7.3 First Floor
Change From Consented Tracker & Comparative Sketches

18.11.20 Rev -
42 Bedford Square:

Schedule of Changes Post Consent - Level First							
Schedule to be read in conjunction with General Arrangement Drawings. The drawings are clouded in orange to show the changes from the consented drawings and in blue to show the changes submitted as part of LBC 2020/2253/L and are pending. They are also numbered in line with the schedule below for clarity.							
Ref No.	Room Number	Changes from consented LBC drawings	Drawing Reference	Description	Heritage Impact	Conservation Officer Verbal / Written Agreement SUBJECT TO LBC APPLICATION	Notes
01F	1.02 Massage Room	Change of use from study to treatment room	(15)AP123_MH (15)AS135 (15)AS136, (15)AS140	Change of use as per clients request	This will have a reduced impact as the intervention is less than what would be required for a treatment room.	Item not discussed with Conservation Officer as areas were in abeyance at time of site visit.	BDP drawings show electrical fittings and sockets to walls only, radiator joinery covers and in timber panelling.

7.4 Second Floor
Change From Consented Tracker & Comparative Sketches

DRAWING TITLE
SECOND FLOOR
PROPOSED WALL LINING
PLAN

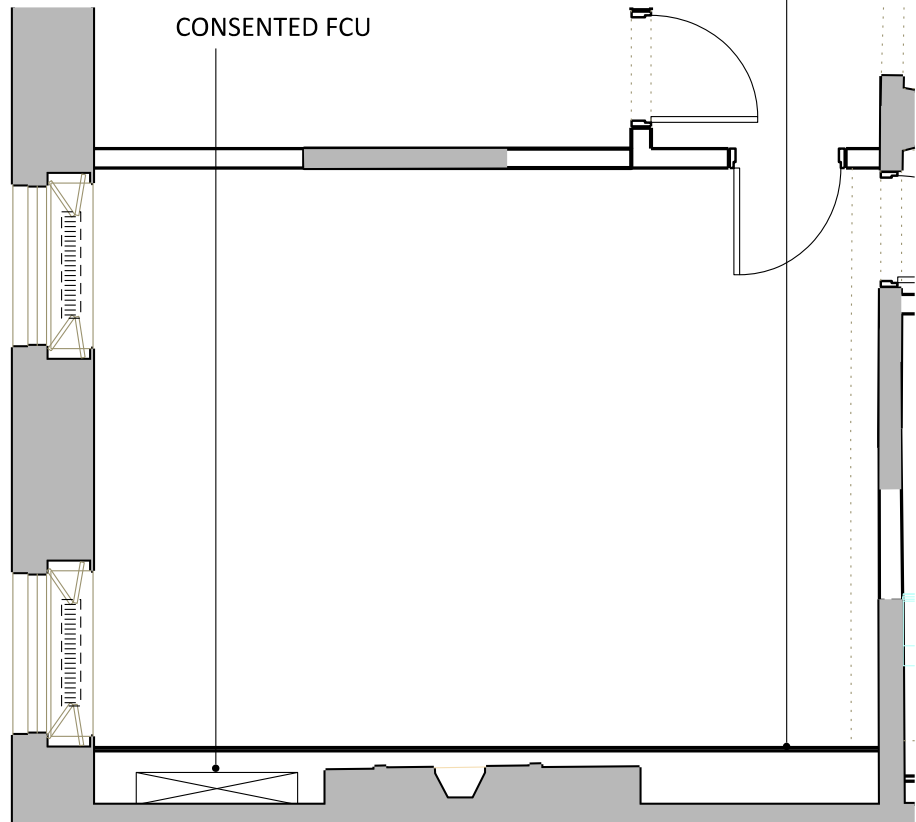
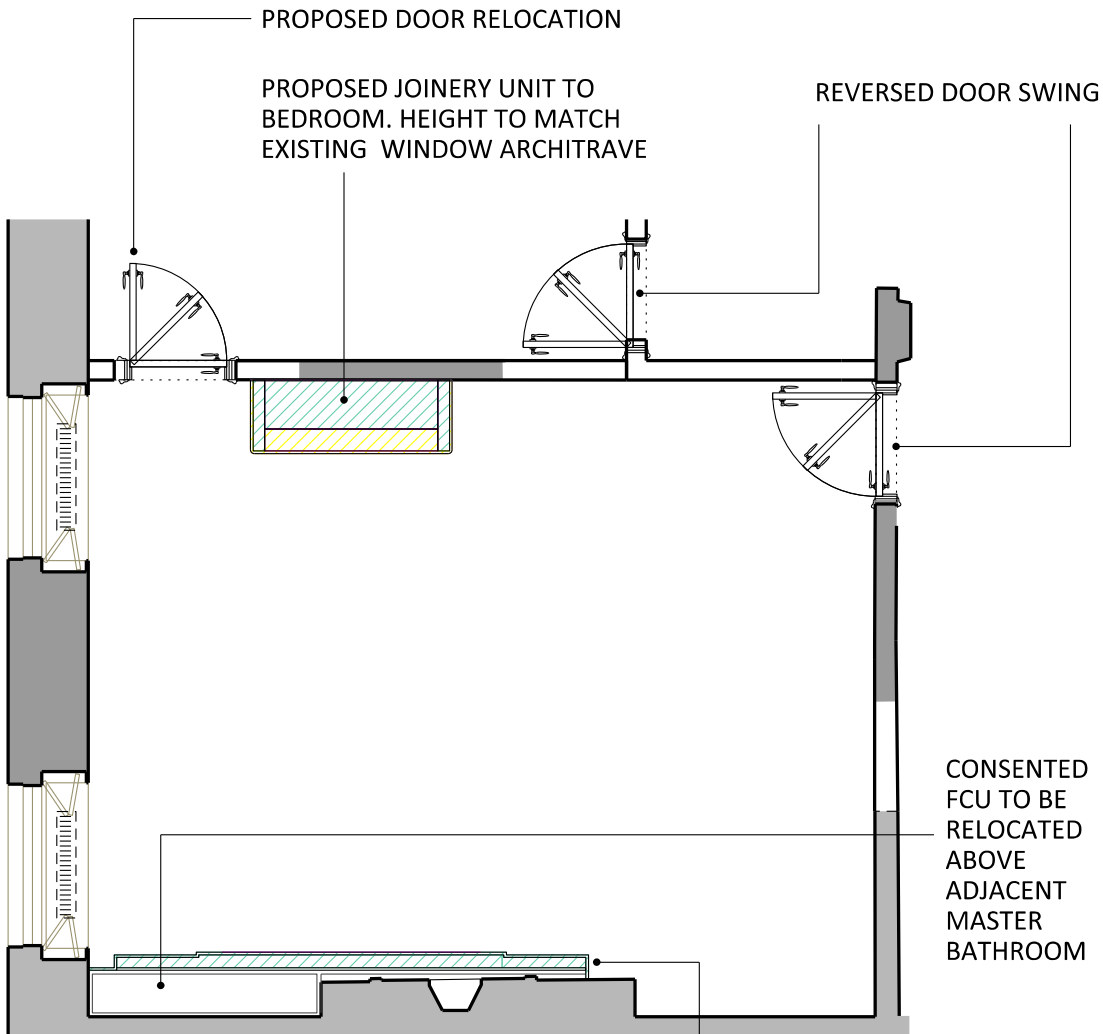
- JOINERY HEIGHT TO MATCH EXISTING WINDOW ARCHITRAVE
- JOINERY 600MM -900MM FROM FINISHED FLOOR LEVEL

POST MEETING NOTE:
Proposed GA's show fixed furniture only.

DRAWING TITLE
SECOND FLOOR
PROPOSED TEA STATION
CUPBOARD PLAN

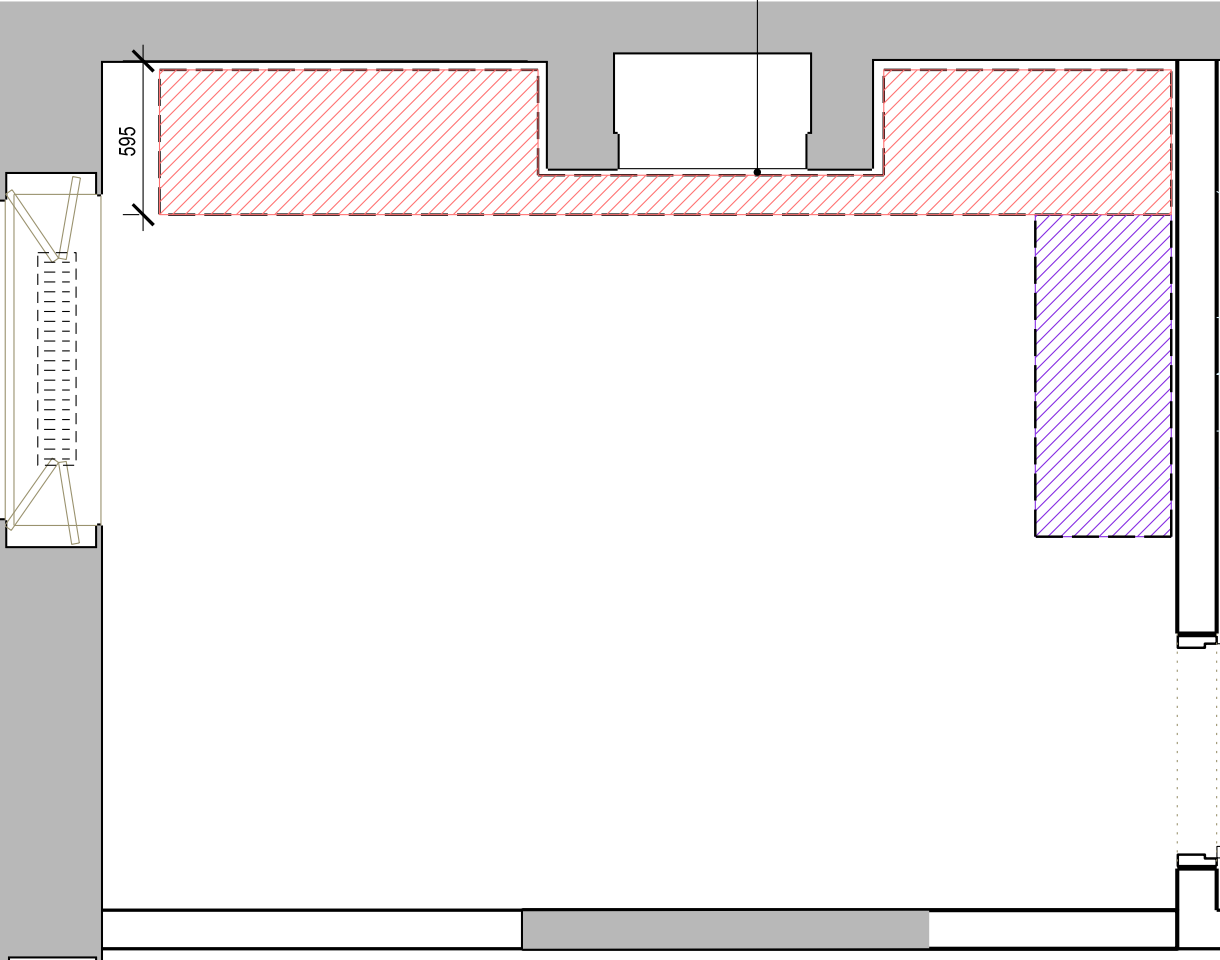
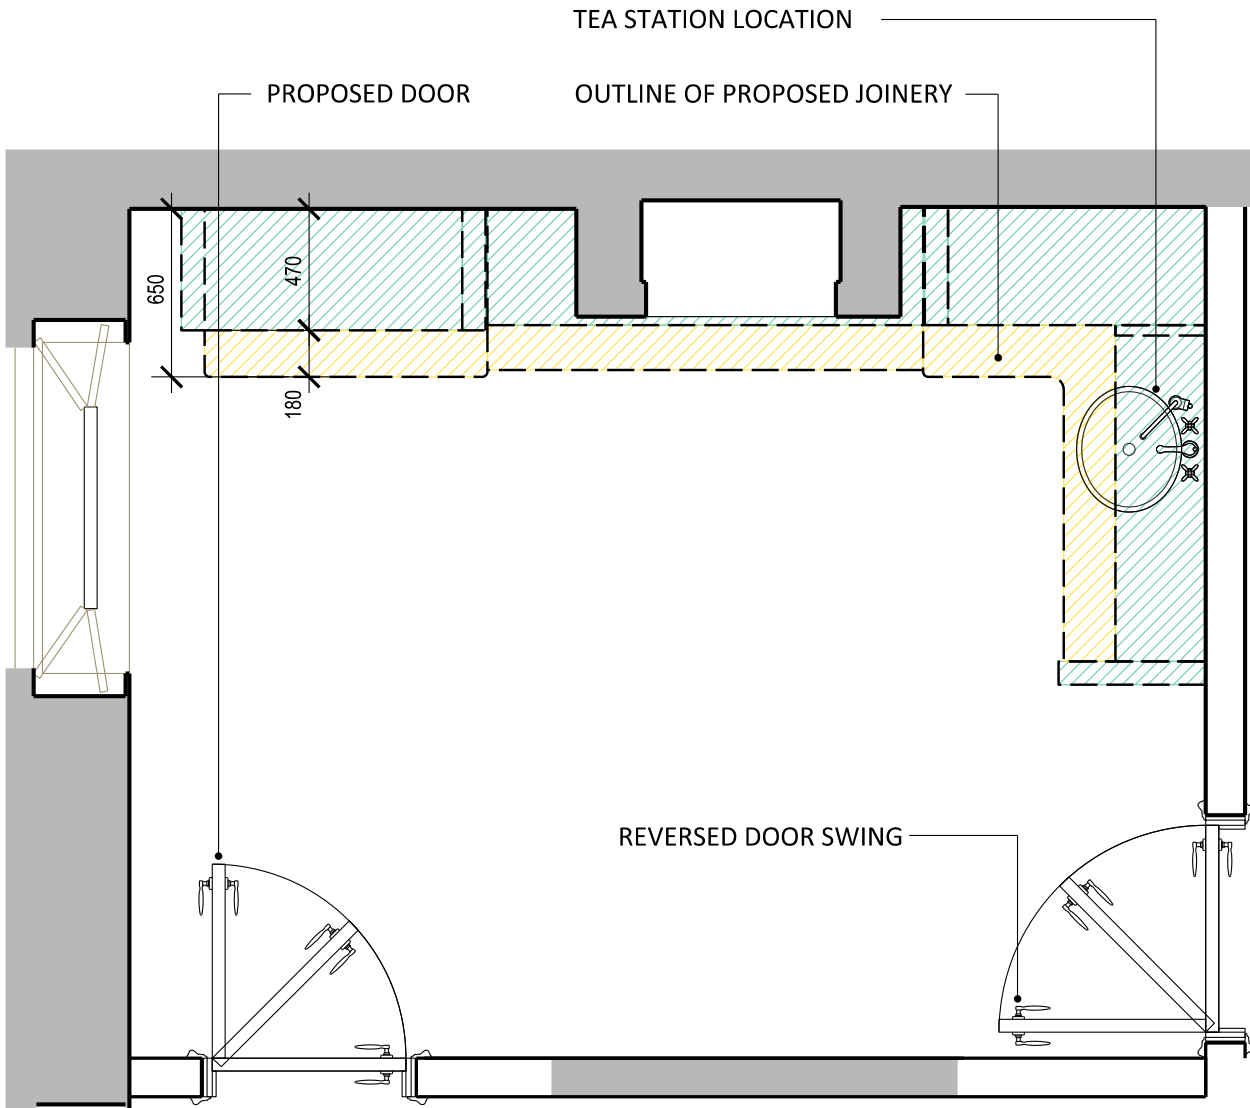
- JOINERY HEIGHT TO MATCH EXISTING WINDOW ARCHITRAVE
- JOINERY 600MM -900MM FROM FINISHED FLOOR LEVEL

POST MEETING NOTE:
Proposed GA's show fixed furniture only.

DRAWING TITLE
SECOND FLOOR
PROPOSED WALL LINING
SECTION

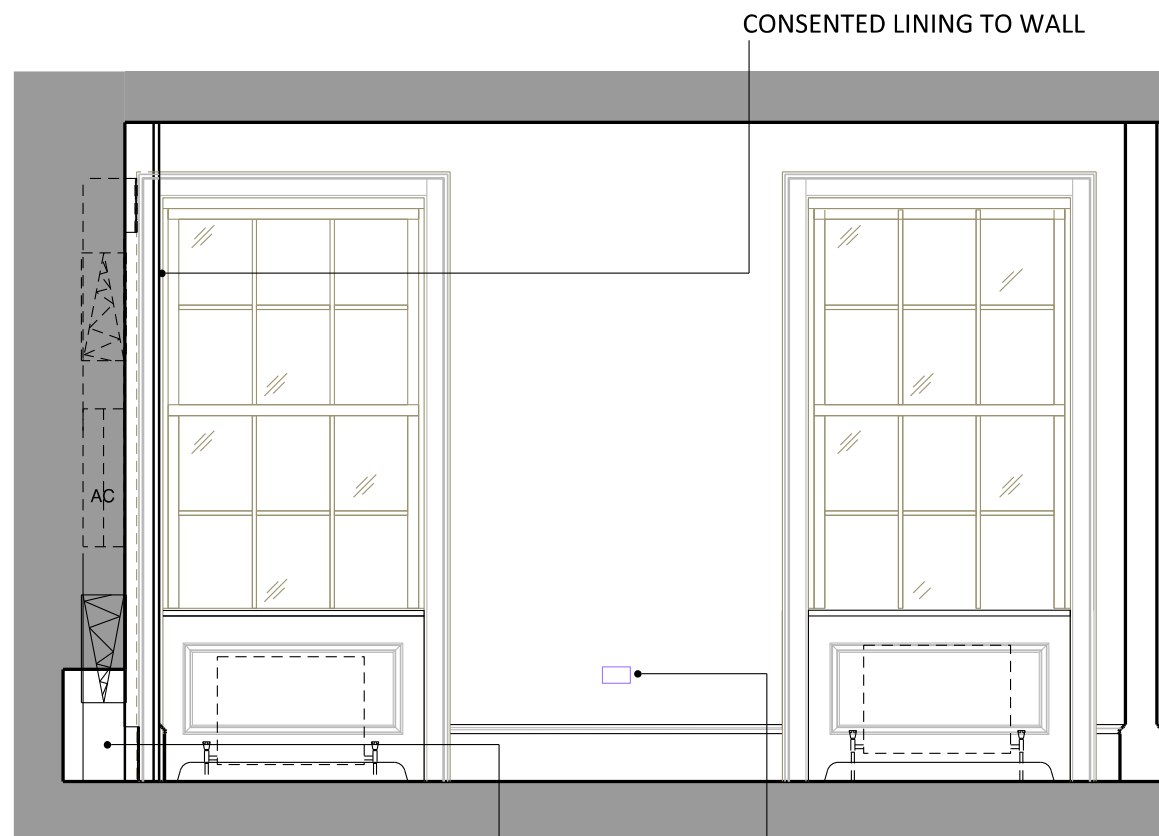
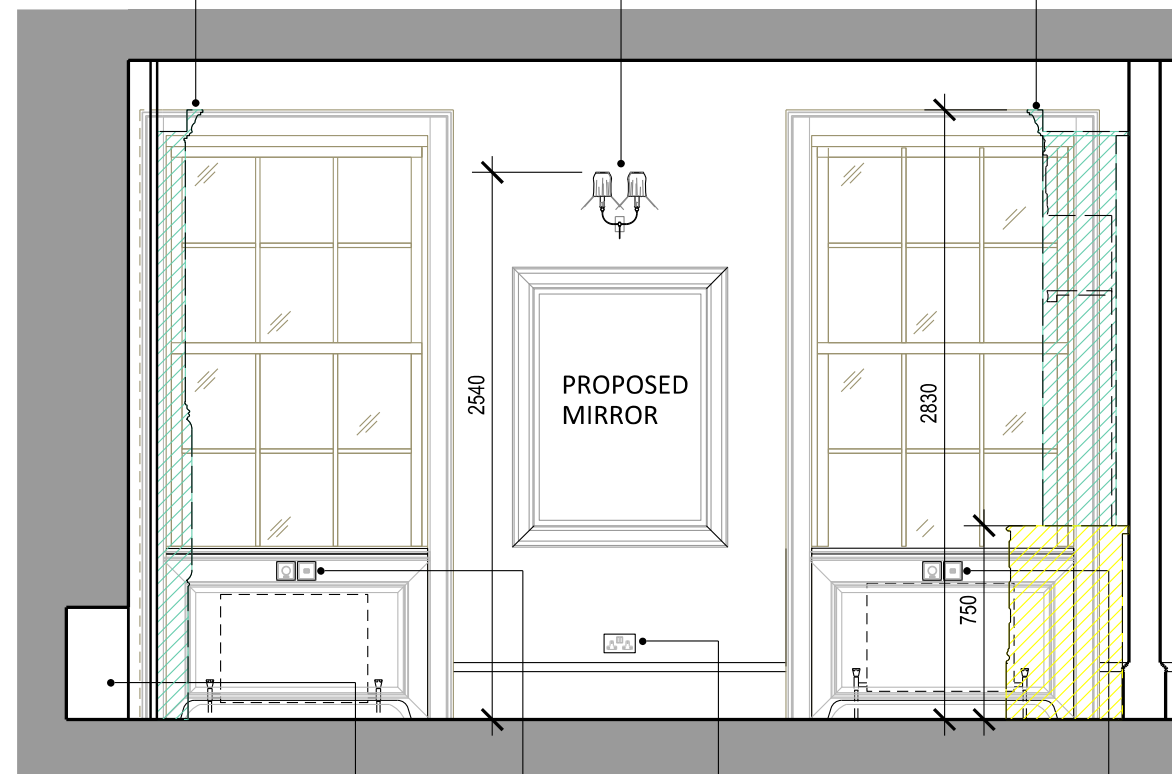
PROPOSED JOINERY BED HEAD IN
FRONT OF WALL LINING. HEIGHT OF
JOINERY TO MATCH EXISTING
WINDOW ARCHITRAVE

PROPOSED CENTRAL WALL
LIGHT ABOVE MIRROR

PROPOSED JOINERY UNIT
TO BEDROOM. HEIGHT
TO MATCH EXISTING
WINDOW ARCHITRAVE

PROPOSED SOCKETS
TO CONSENTED
RADIATOR COVERS

PROPOSED SOCKETS
TO CONSENTED
RADIATOR COVERS

CONSENTED FCU TO BE RELOCATED
ABOVE ADJACENT MASTER BATHROOM
